**IEEE P802.15**  
**Wireless Personal Area Networks**

Project	IEEE P802.15 Working Group for Wireless Personal Area Networks (WPANs)	
Title	Proposed Text on $\pi/2$ BPSK and (G) MSK description	
Date Submitted	September, 9 <sup>th</sup> , 2008	
Source	[R. Funada, M.A Rahman, C.S Sum, T. Baykas, J. Wang, H. Harada, M. Umehira, S. Kato]	Voice: [+81-46-847-5055] Fax: [+81-46-847-5440] E-mail: [funada@nict.go.jp]
Re:	802.15.3c Teleconference Meeting	
Abstract	IEEE 802.15 Task Group TG3c Comment Resolution	
Purpose	Resolutions for the $\pi/2$ BPSK and (G) MSK description	
Notice	This document has been prepared to assist the IEEE P802.15. It is offered as a basis for discussion and is not binding on the contributing individual(s) or organization(s). The material in this document is subject to change in form and content after further study. The contributor(s) reserve(s) the right to add, amend or withdraw material contained herein.	
Release	The contributor acknowledges and accepts that this contribution becomes the property of IEEE and may be made publicly available by P802.15.

### 12.2.2.1.1 $\pi/2$ BPSK, Pre-coded (G)MSK

Figure 189—Constellation maps for modulation schemes: (a)  $\pi/2$  BPSK, (b) pre-coded (G)MSK, (c)  $\pi/2$  QPSK

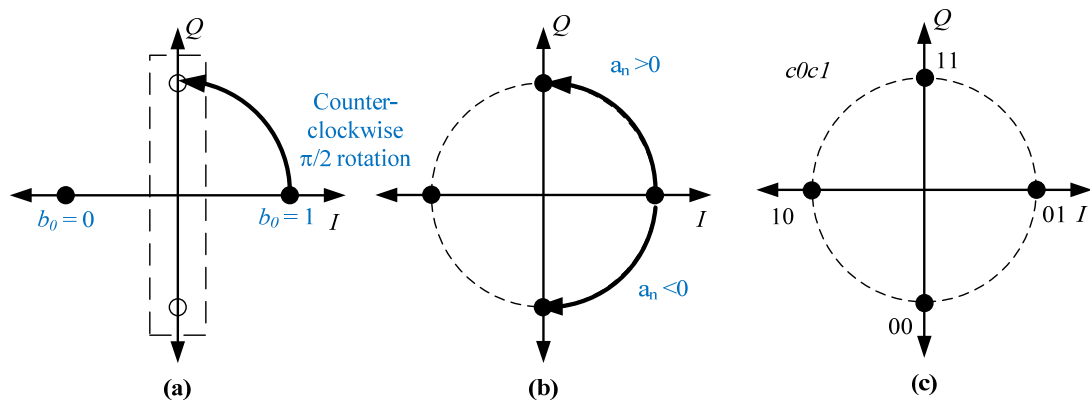
The  $\pi/2$ -shift BPSK ( $\pi/2$  BPSK) modulation uses two phases separated by  $\pi$  radian, as illustrated in Figure 189(a). The  $\pi/2$  phase shift is made counter-clockwise to eliminate the  $\pi$  phase shift. Figure 189(a) shows signal constellation of  $\pi/2$  BPSK signals. As shown in Figure 189(a), the black dot indicates the initial constellation point on the horizontal axis. In the next bit timing, the black dot is rotated to either hollow dot on the vertical axis. If  $b_0, b_1, \dots, b_{n-1}$  are unipolar bits to be transmitted, they are mapped to bipolar bits  $d_0, d_1, \dots, d_{n-1}$ , where bit “0” is mapped on “-1” and bit “1” on “+1”. The bipolar bit stream is then mapped onto constellation points  $z_n$  as

Pre-coded MSK are continuous phase modulation schemes by applying differential pre-coding before the MSK modulation. Note that the MSK constellation mapping is approximately equivalent to the  $\pi/2$ -BPSK constellation as shown in Figure 189(b). The differential pre-coding is defined by

where,  $z_{-1}$  is  $-j$ . This encoding means the odd bits are mapped onto the real axis and the even bits are mapped onto the imaginary axis, as shown in Figure 189(b). Hence it is equivalent to the  $\pi/2$ -BPSK constellation as shown in Figure 189(a) (Note that the normalization factor is 1). The maximum phase shift of MSK is equal to  $\pi/2$  radian. The maximum phase shift of GMSK is equal to or less than  $\pi/2$  radian due to Gaussian filtering. Note that filtered waveform of each modulation shall satisfy Transmit PSD mask as in 12.2.7.4.
